**STAFF REPORT
FOR THE PLANNING COMMISSION**

FILE NUMBER: CUP-12-03/DR-12-07

REQUEST: Conditional Use and Class I Design Review approval for exterior site modifications and exterior building remodeling at Willamette Primary School, 1403 12th Street.

Excerpt from Detailed Site Plan, Sheet L101 (Page 65 of Exhibit PC-4). Captions, arrows, and orange line representing 2nd floor wall added by staff.

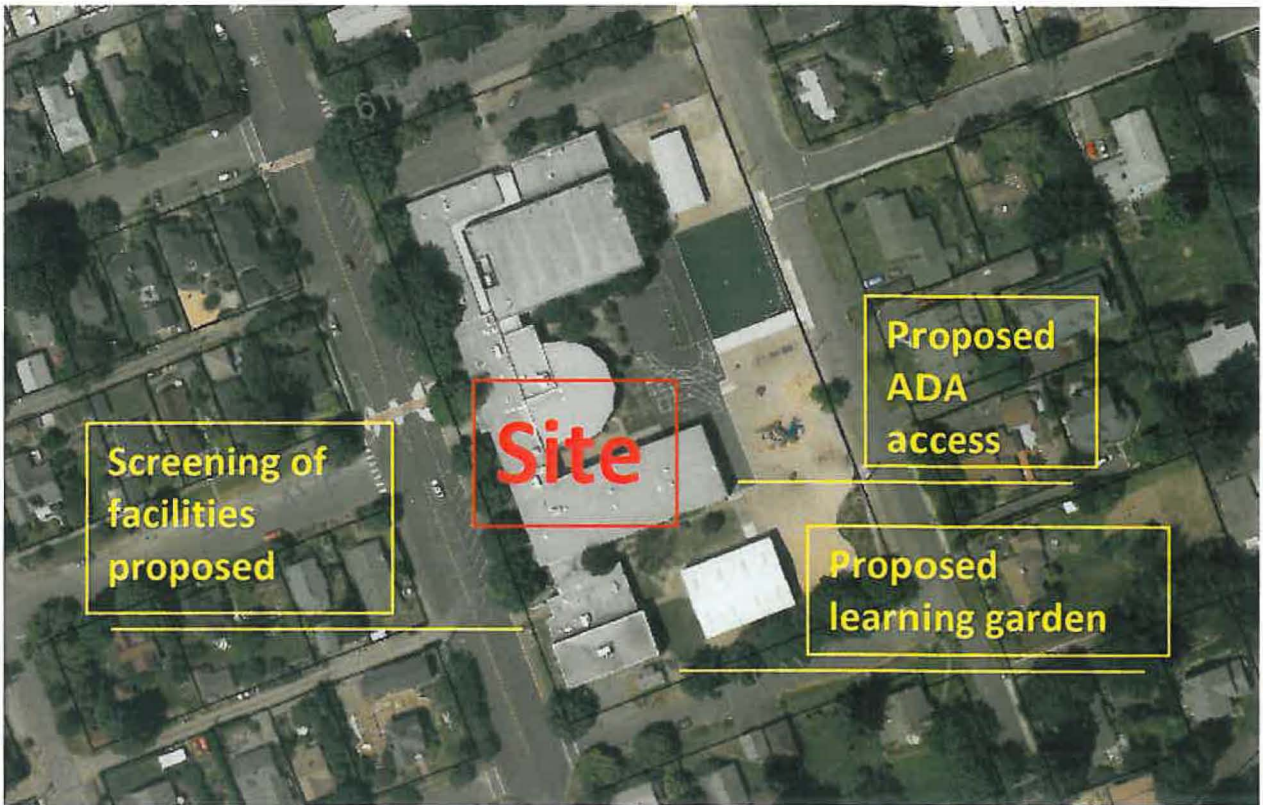
All of the proposed site changes can be seen on Sheet L101, the Detailed Site Plan, on Page 65 of Exhibit PC-4. All changes to the building, as well as the elevations of the proposed walls and gate around the trash/recycling area, are presented on the exterior elevations sheet on Page 66 of Exhibit PC-4.

New fencing is proposed south of the learning garden and greenhouse area, and west of the greenhouse along the small gravel parking area (see Page 65 of Exhibit PC-4, Detailed Site Plan, Sheet L101). Staff recommends Condition of Approval 3, which requires planting arborvitae to screen this fencing from the street and nearby residential uses in case the fence material used is incompatible with the site’s surroundings or makes views of this area less attractive. Specifically, the proposed condition calls the planting of arborvitae along all of the new fence west of the tree labeled on the site plan L101 as “22 inch maple”(which marks the east end of the new fencing). The east end of the fencing also will be screened by the maple and other trees to the east. Staff does not see the need for other additional conditions relating to items listed above in Section (C), but the Planning Commission can add others if it finds this necessary to make the use compatible with the neighborhood.

1. Site Plan and Elevation Drawing. With the exception of modifications required by these conditions, the project shall conform to the Site Plan and Detailed Site Plan, dated February 14, 2012 (on pages 64 and 65, respectively, of Exhibit PC-4) and the exterior elevations sheet on Page 66 of Exhibit PC-4.
2. Learning Garden Use Hours for Activities Involving Amplified Sound. The learning garden shall not be used for activities involving amplified sound, except for instruction during regular school hours.
3. Arborvitae Screening of New Fencing. The new fencing proposed on the south side of the site shall be screened with arborvitae west of the tree labeled 22-inch maple tree shown on Sheet L101, Detailed Site Plan (on page 65 of Exhibit PC-4).
